# West Cambridge Development

## MASTER PLAN REVIEW

APRIL 2004

Forming an Amendment to:

2004 Master Plan Review  
 Plot Specific Guidelines - Plot D  
 Figure 53 rev. A

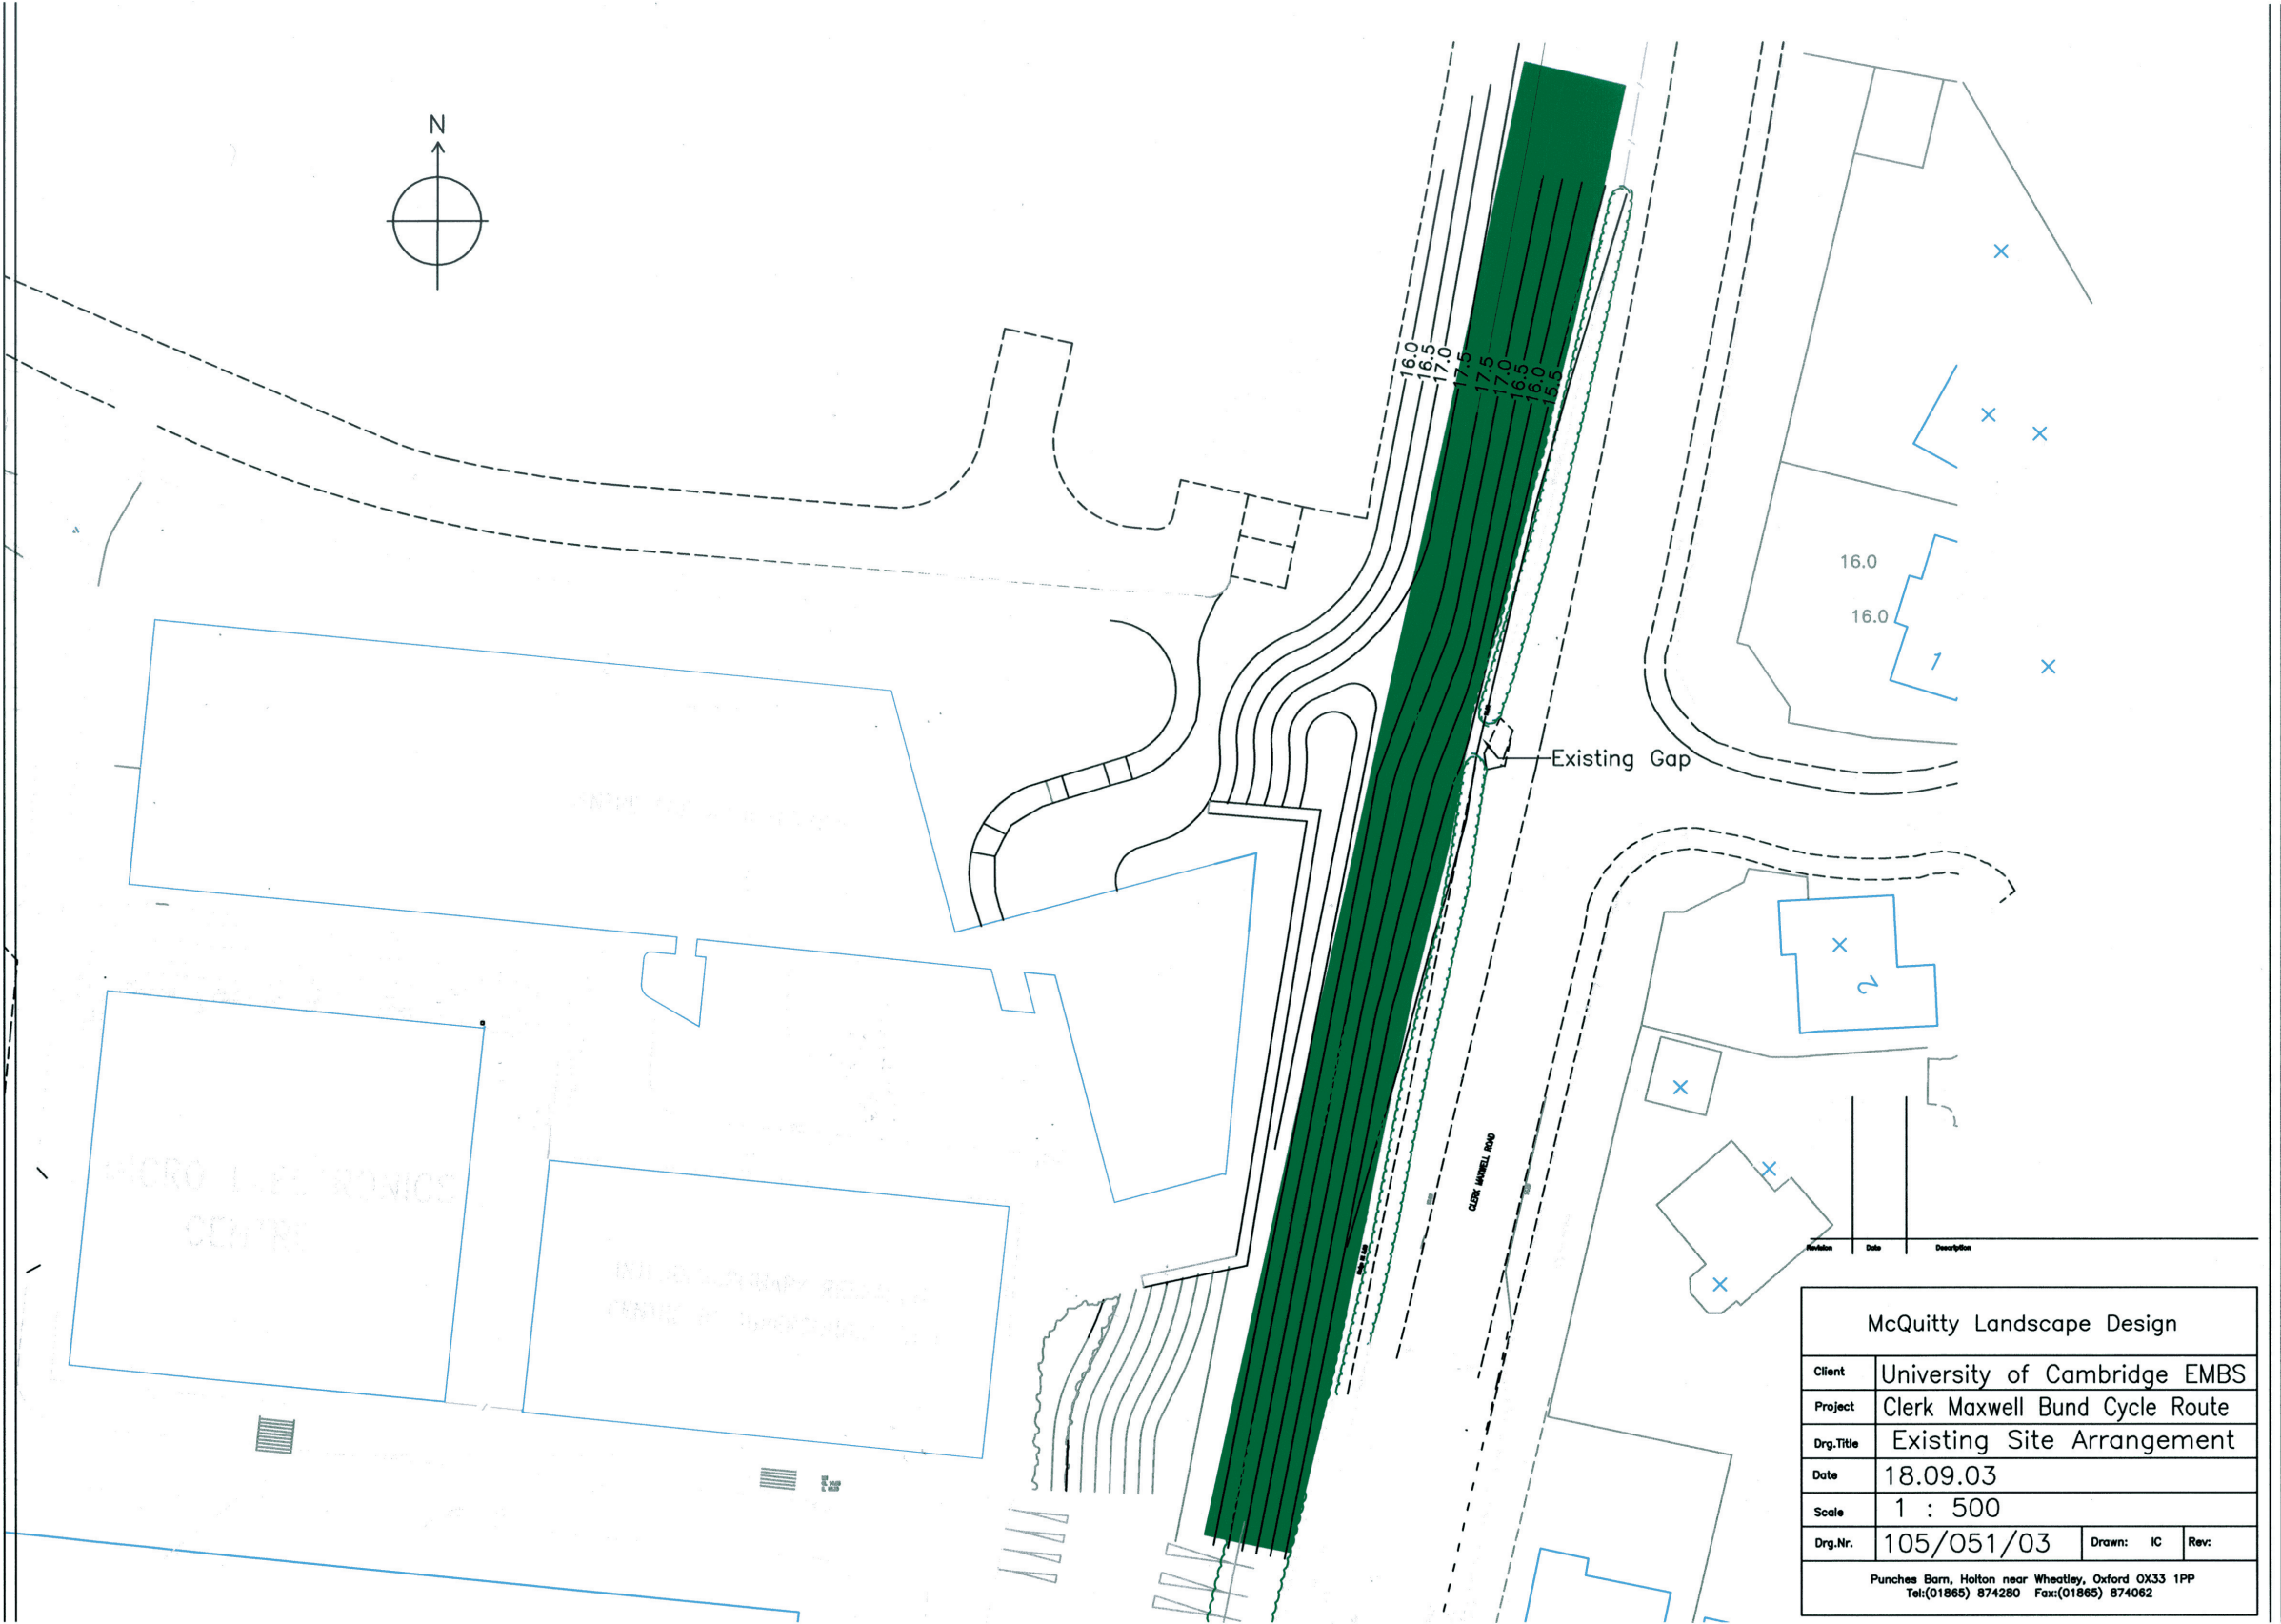
Existing 3rd paragraph reads:  
*“Some further development is planned. Beyond this development, any further proposals in the central area of the site (shown shaded on Figure 53) will be limited to small scale alterations and extensions to existing activities and can be judged individually on their merits independently of the*

Beyond these developments, any further proposals in the central area of the site (shown shaded on Figure 53 rev A) will be limited to small scale alterations and extensions to existing activities and can be judged individually on their merits independently of the development of the rest of the site."

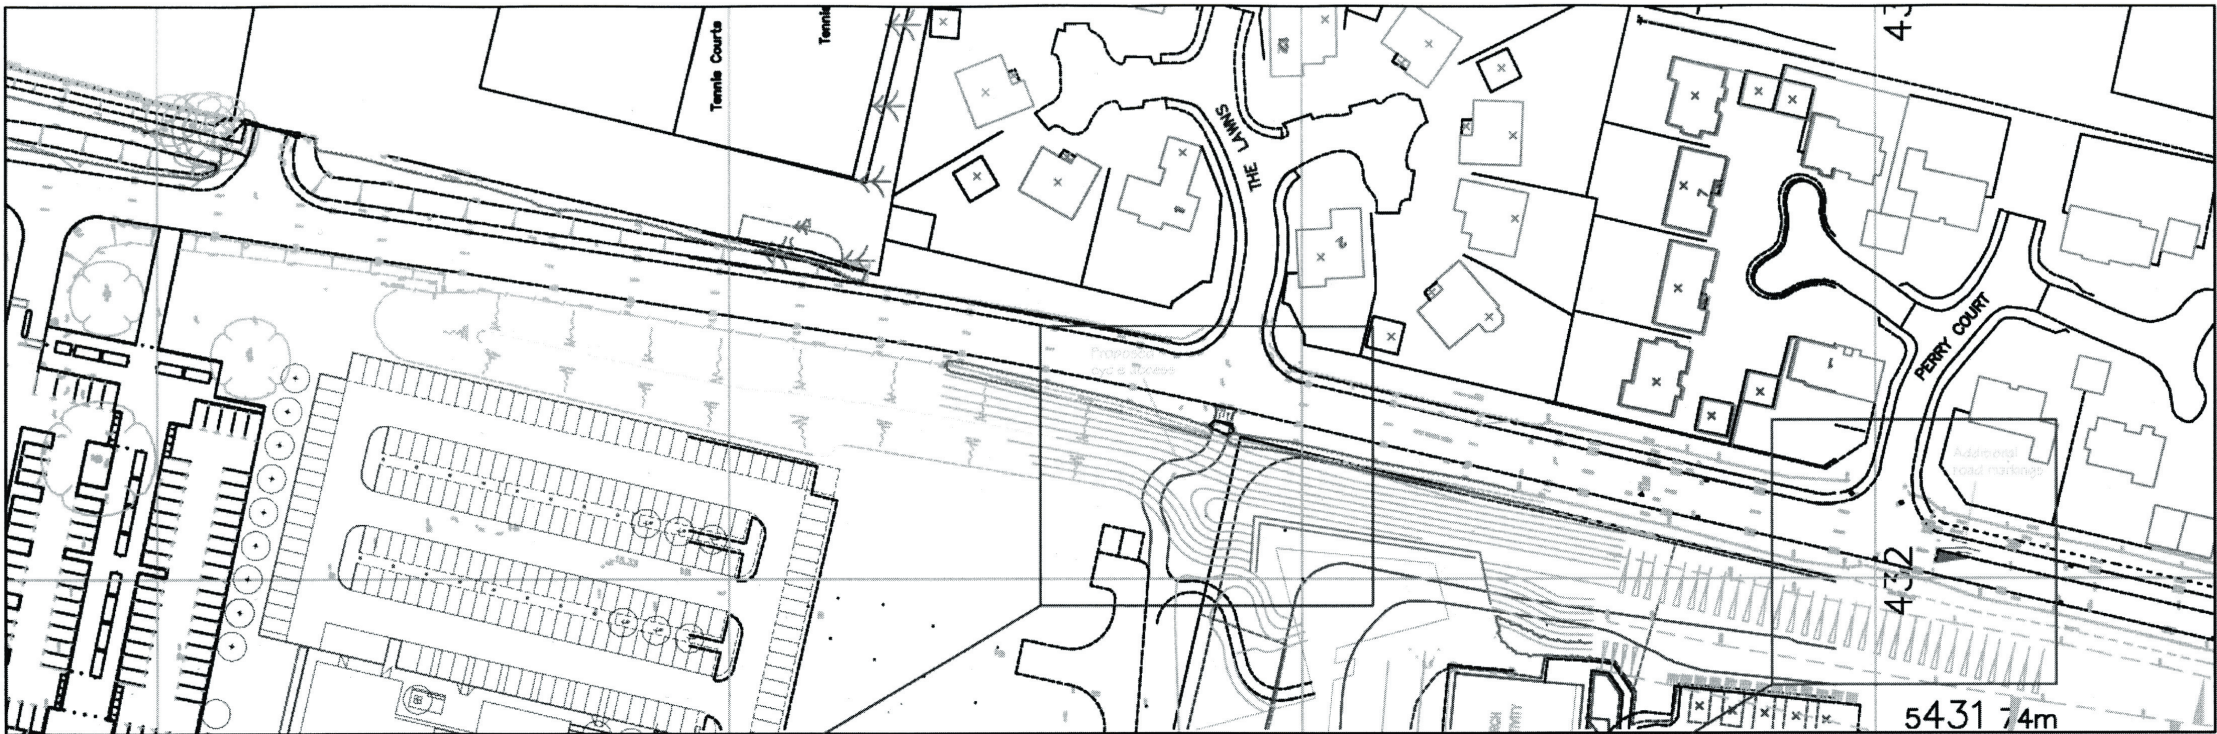
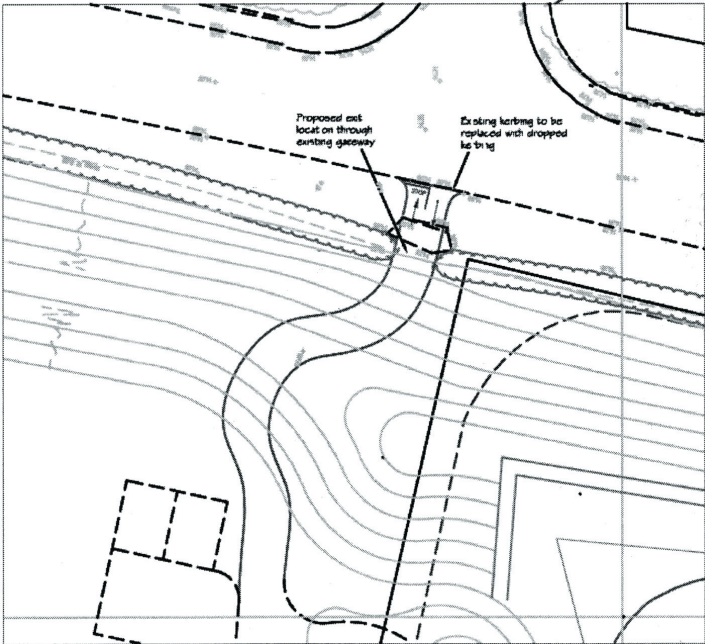
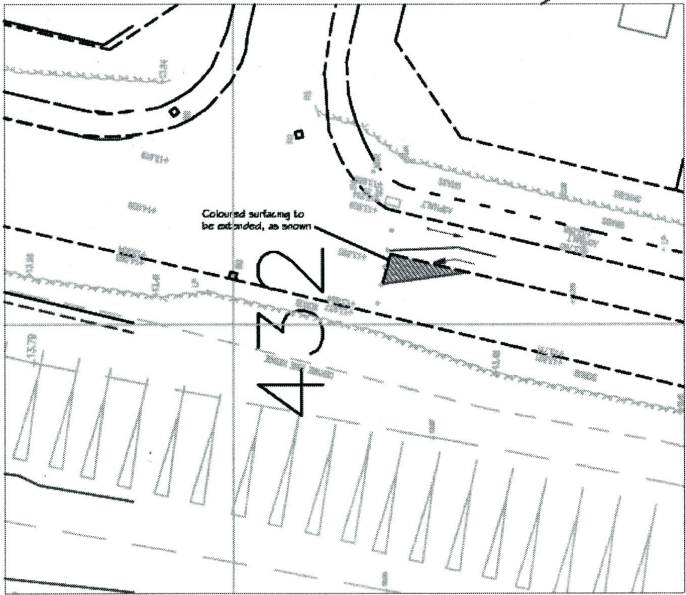
McQuitty Landscape Design drawing 105/051/01 Rev A shows the line of the proposed pedestrian/cycle route. The route avoids making a direct cut through the planted bank which provides a screen between the West Cambridge site and the residential area opposite. Rather it follows a curved line which retains the screening impact of the bank and the accompanying planting. The revised line allows the pedestrian/cycle route to take advantage of an existing gap in the hedgerow where only minimal trimming will be necessary to allow the path to go through.

McQuitty Landscape Design drawing 105/051/02 illustrates an elevational view of the access at the point where it joins Clerk Maxwell Road, seen from the road. It shows that the mound and its planting as well as the retained hedgerow along Clerk Maxwell Road
